T10/04-029r3, SAS-1.1: Close Port Selector Detection Gap

To: T10 Technical Committee  
From: Robert Sheffield (Robert.L.Sheffield@intel.com), Intel Corporation  
Date: June 16, 2004  
Subject: T10/04-029r3, SAS-1.1: Close Port Selector Detection Gap

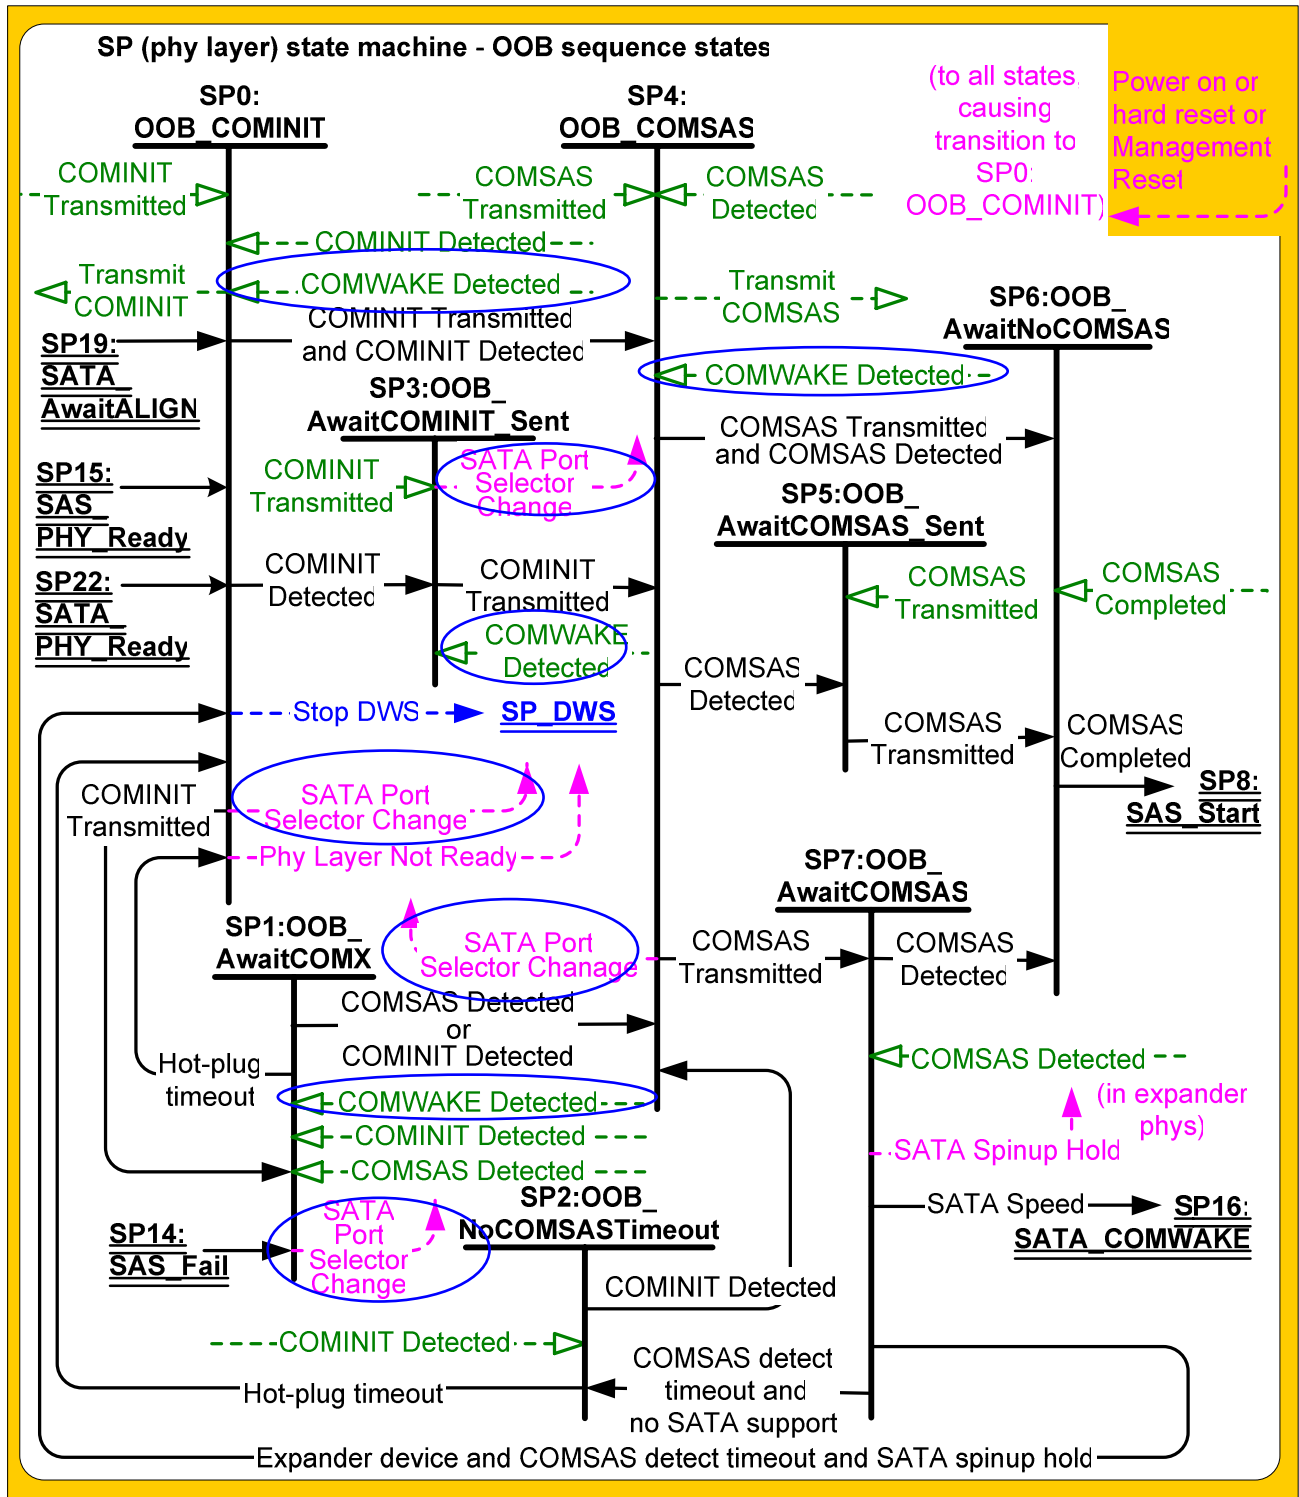
Modify figure 68 in subclause 6.7.3.1 OOB sequence states overview as follows to add SATA Port Selector Change messages sent to the XL State Machine upon receiving the COMINIT Detected message:

Figure 90 — XL (link layer for expander phys) state machine (part 1)

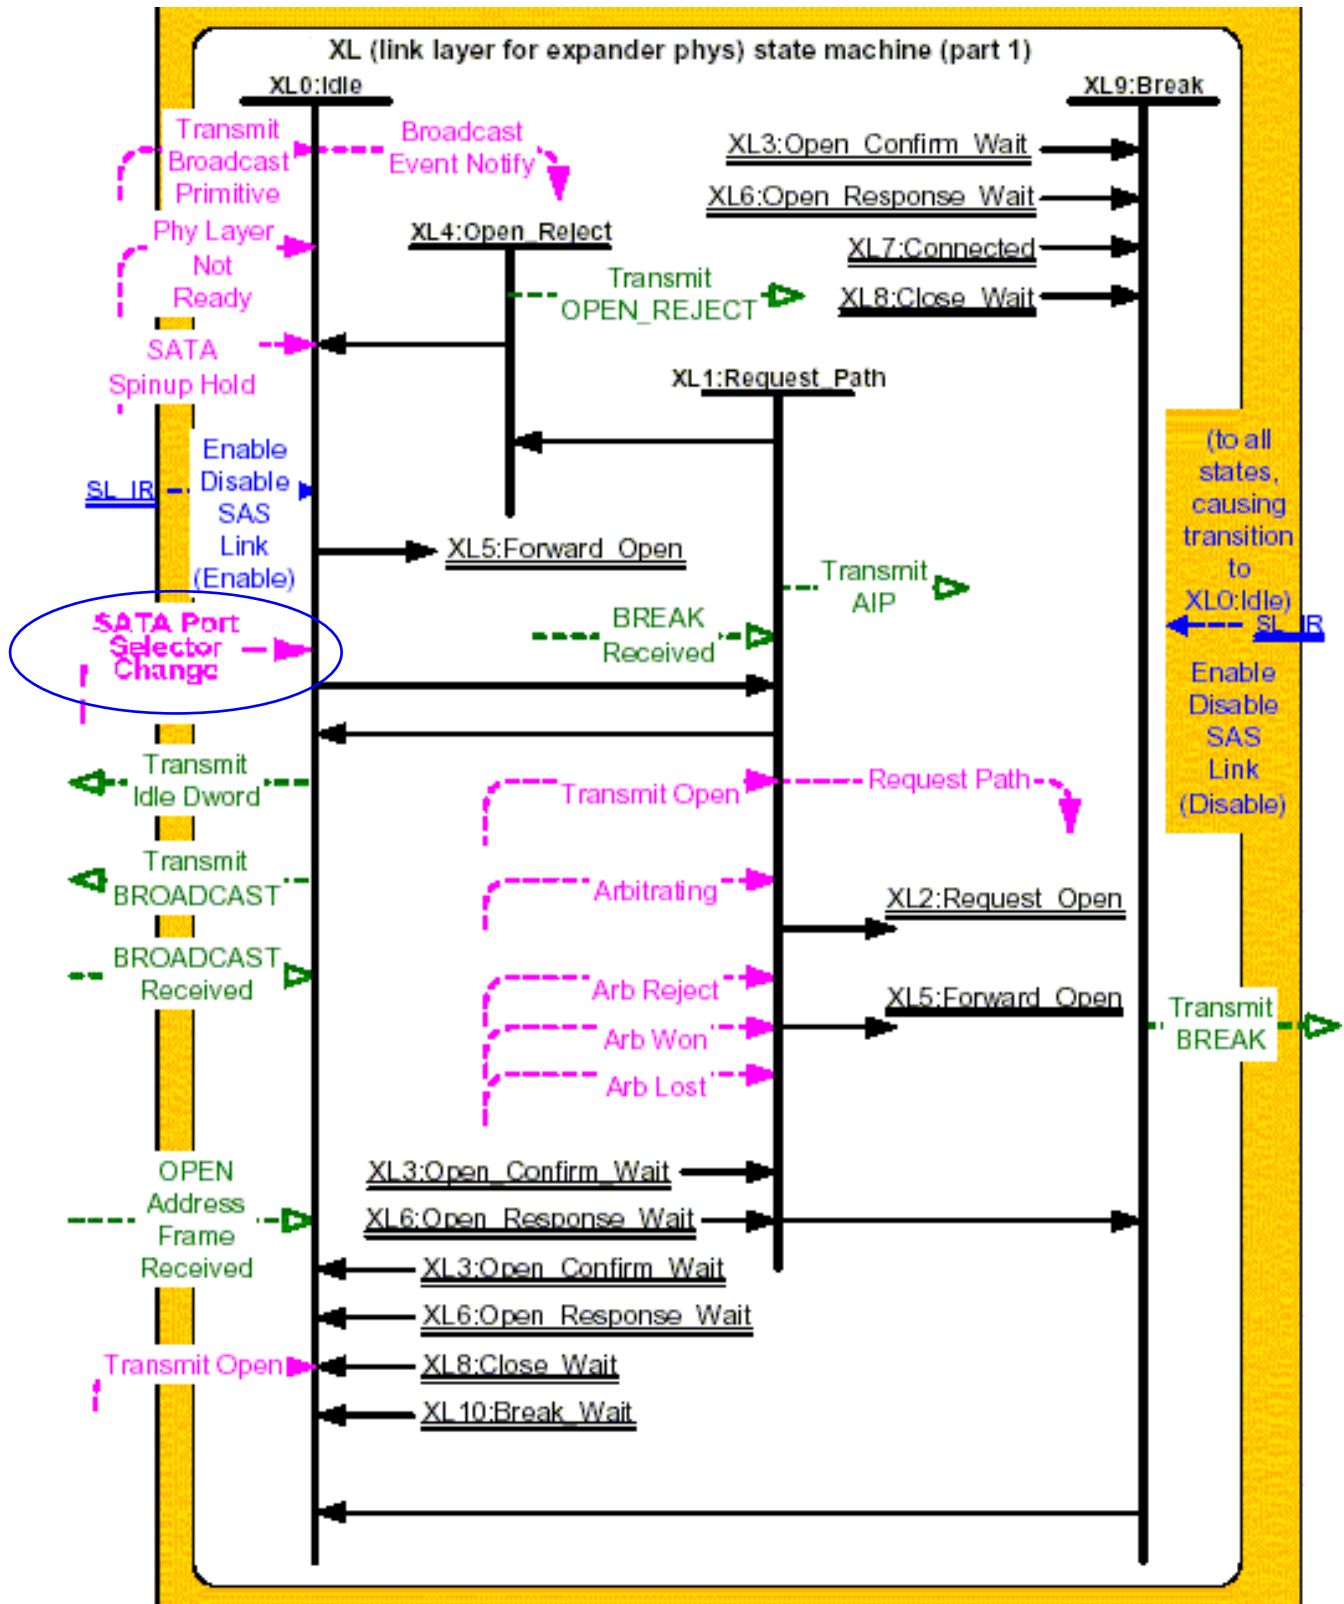
Modify figure 90 in subclause 7.15.1 as follows:

If a SATA Port Selector Change confirmation is received, this state shall send a Broadcast Event Notify (SATA Port Selector Change) request to the BPP.
